**Volare Carburetors, LLC**

**Service Bulletin: SB-8 Rev B**

**SUBJECT – MA-4-5™, MA-5™ and MA-6™ SERIES CARBURETORS  
PUMP DISCHARGE VALVE.**

**Figure 2**

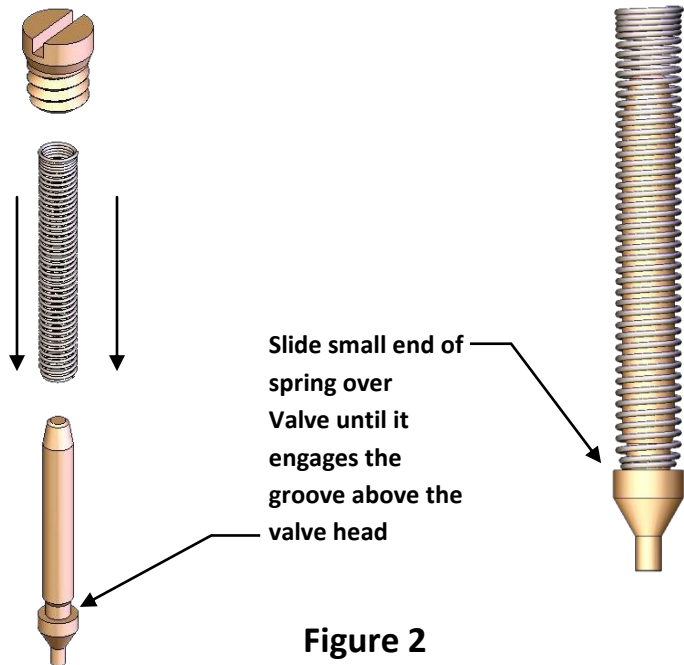
6a. Install the valve spring, small end first, over the valve stem, See Figure 2. Push the spring onto the stem until it engages in the groove above the valve head. Install the valve head first into the bowl. Apply a drop of oil to the valve cap threads, install it, and tighten it to 20 -25 inch pounds.

**Figure 1**

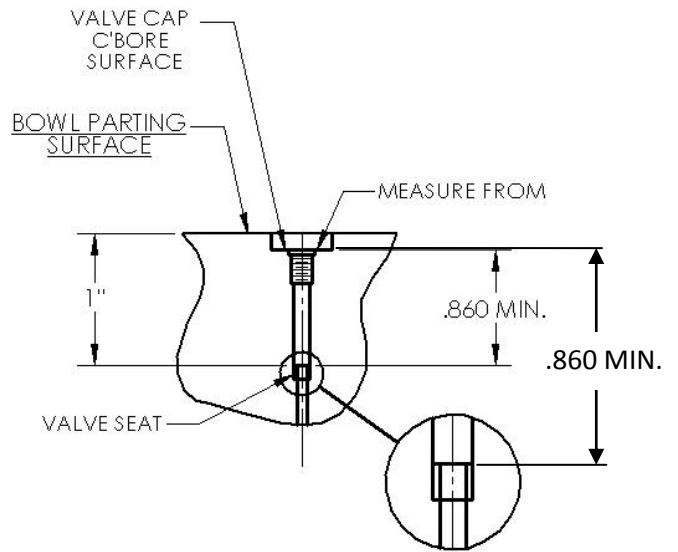
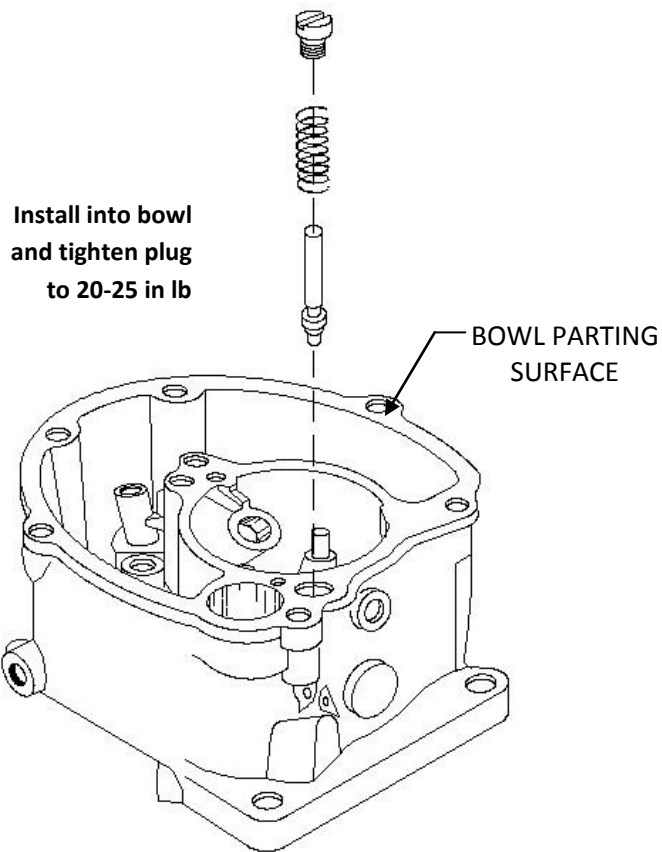
6. **Installation:** Measure the distance from the valve cap counter bore surface to the valve seat as shown in Figure 1, below. If the dimension is at least .860 inches (21.8 mm) proceed to install a spring loaded valve in accordance with the paragraphs below. If the dimension is less than .860 inches (21.8 mm) reinstall a weighted valve or contact Volare for instructions for re-machining the valve seat to obtain a suitable dimension.
